**Planning Department
Transportation Development Services**

Re: Valley High School
1505 Candelaria Rd., NW
Traffic Circulation Layout
Engineer's/Architect's Stamp dated 9-20-15 (G13-D010)

SITE PLAN

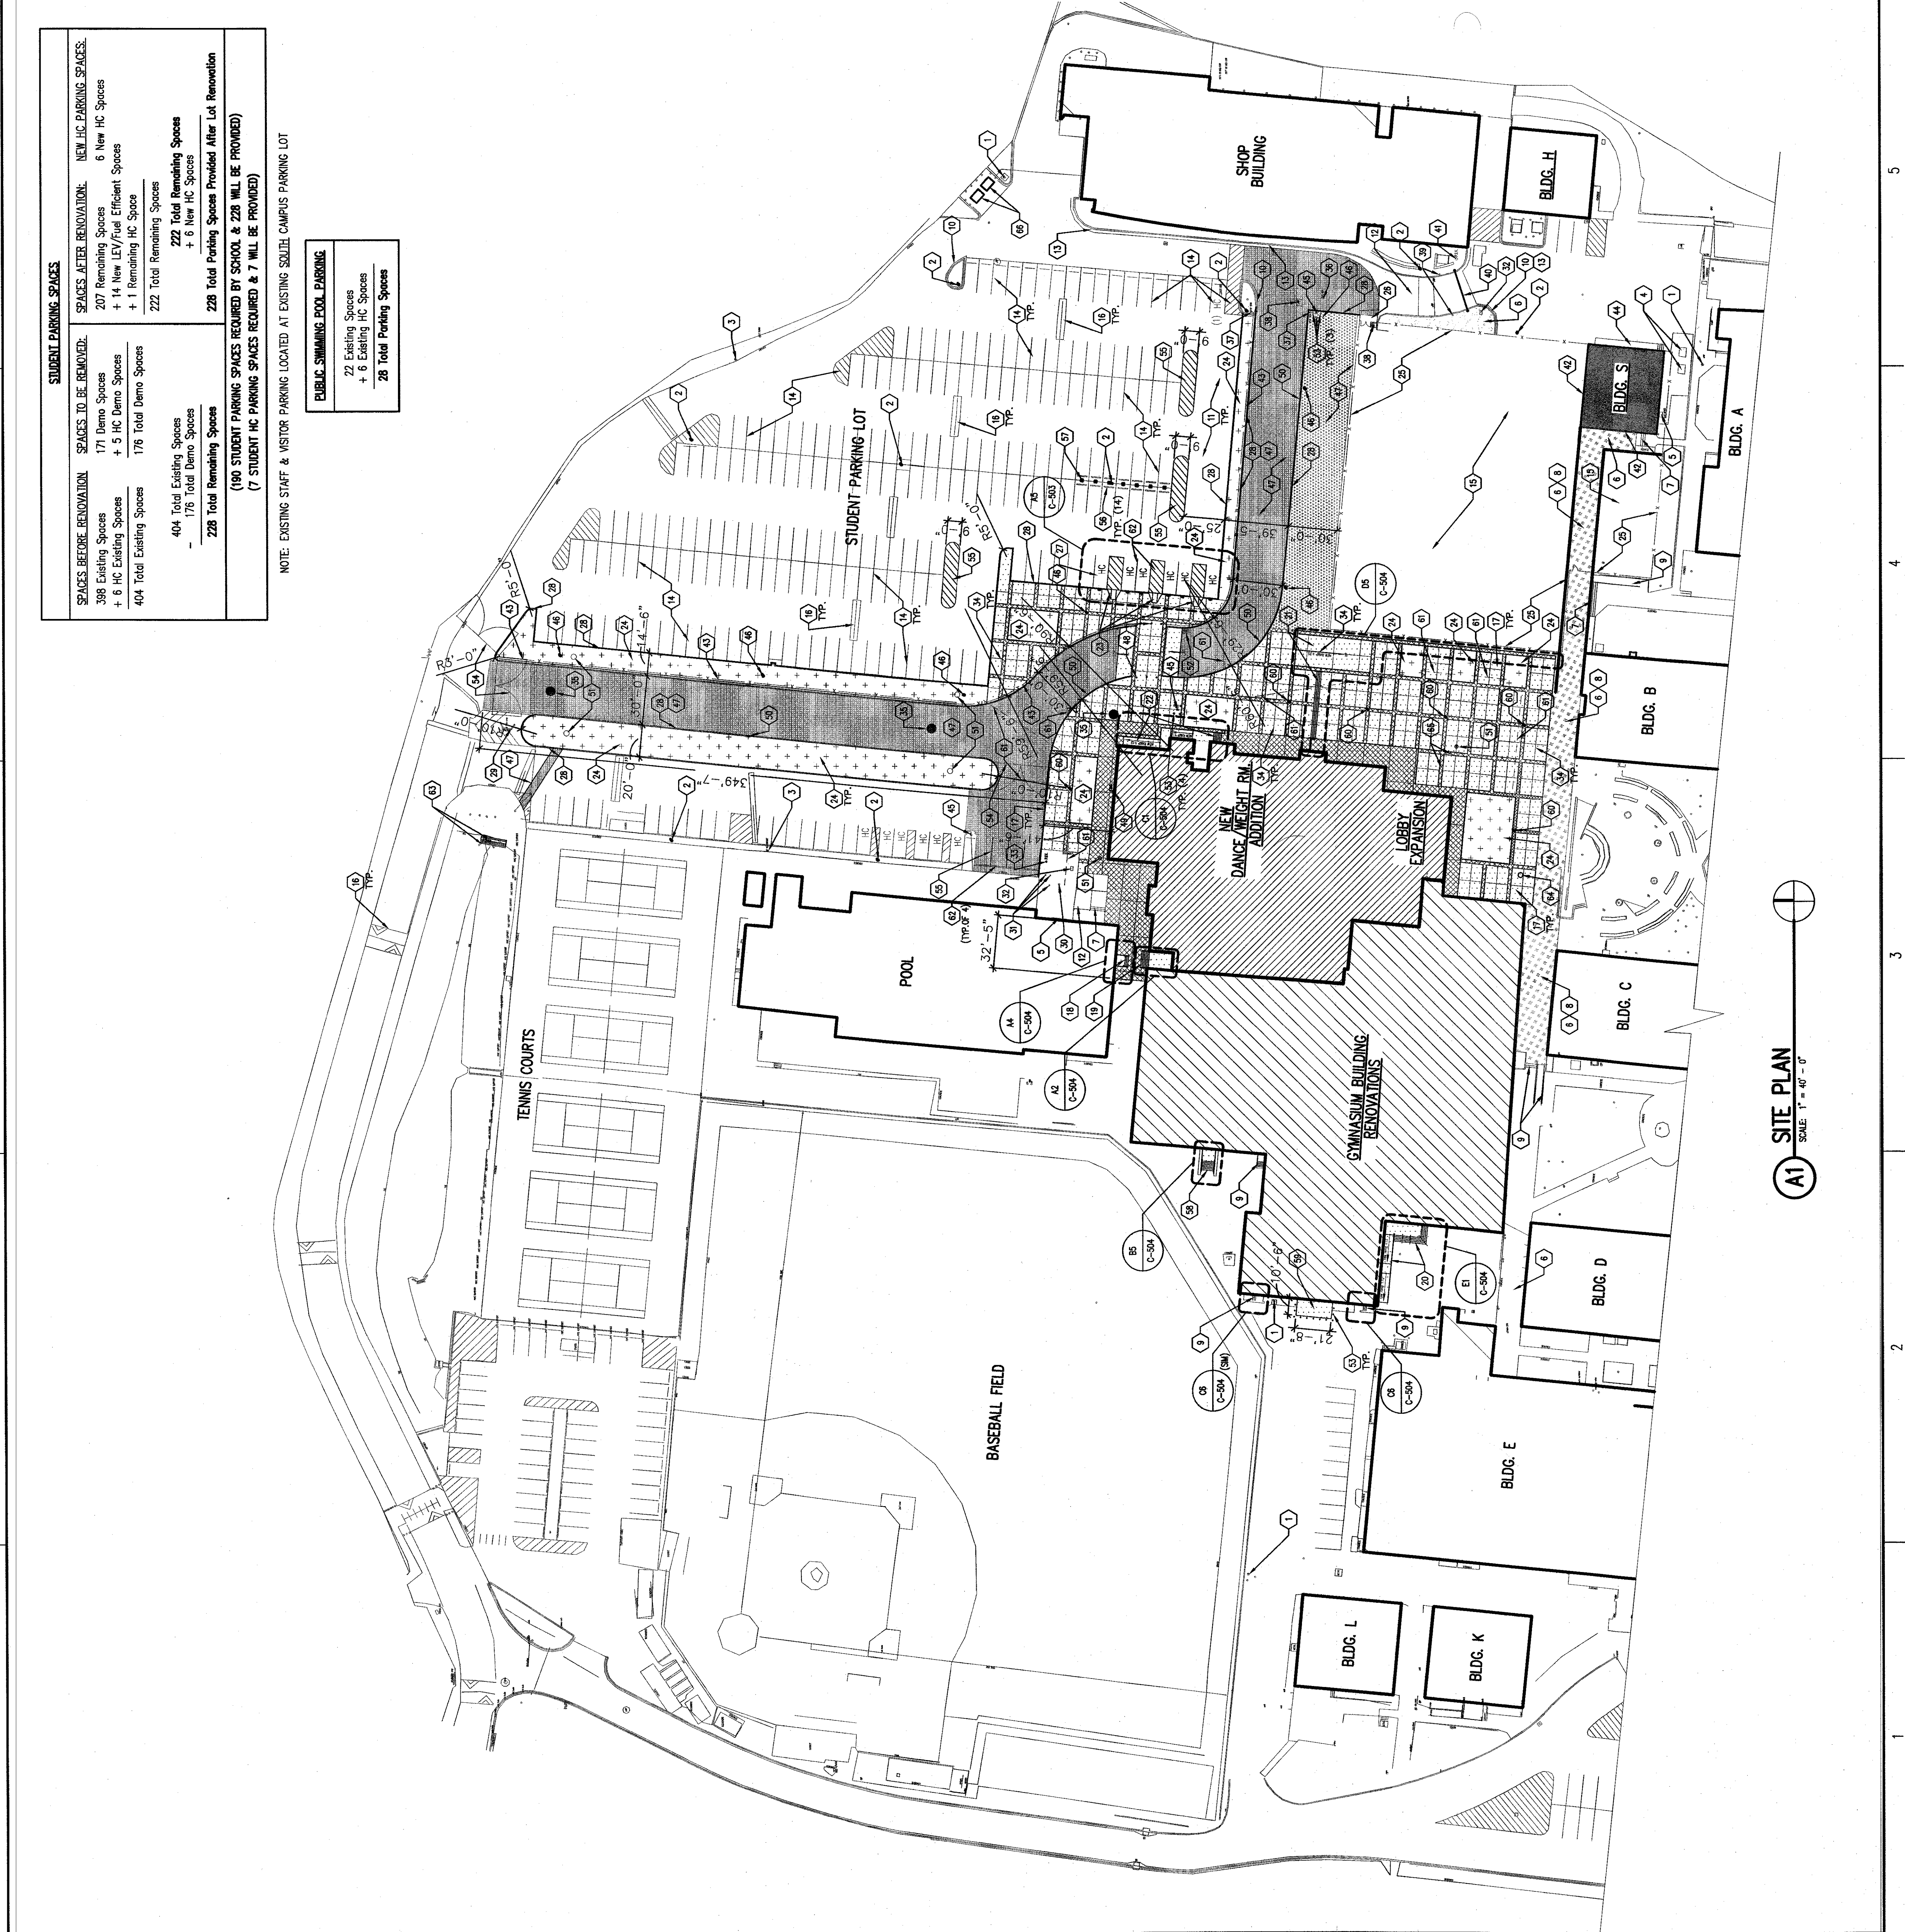
1. Please show a vicinity map showing the location of the development in relation to streets and well known landmarks.
2. Clarify the extents of the current phase.

3. Identify all existing access easements and rights of way with dimensions.
4. Identify the right of way width, medians, curb cuts, and street widths leading to the Phase I Renovation parking lot.

5. Please list the width and length for all existing and proposed parking spaces, including ADA Handicap parking spaces.
6. The handicap accessible spaces must be a minimum of 8.5 feet in width.

7. The handicap accessible spaces must include an 8-foot wide van access aisle; all other aisles should be 5 feet in width.
8. The ADA accessible parking sign must have the required language per 66-7-352.4C NMSA 1978 **"Violators Are Subject to a Fine and/or Towing."** Please show this detail on the drawing.

9. The ADA access aisle shall have the words **"NO PARKING"** in capital letters, each of which shall be at least one foot high and at least two inches wide, placed at the rear of the parking space so as to be close to where an adjacent vehicle's rear tire would be placed. (66-1-4.1.B NMSA 1978) Please show or state this detail.

10. Show all drive aisle widths and radii.

11. Per the DPM, a 6 ft. wide ADA accessible pedestrian pathway is required from the HC parking stall access aisles to the building entrances. Please clearly show this pathway to entrances from all HC parking stalls.
12. Provide a min 6" or max 8" high concrete barrier curb or other acceptable barrier between landscaping and parking areas and/or drive aisles. Please call out this detail on drawing.
13. Design delivery vehicle route needs to be shown.
14. Please include two copies of the traffic circulation layout at the next submittal.
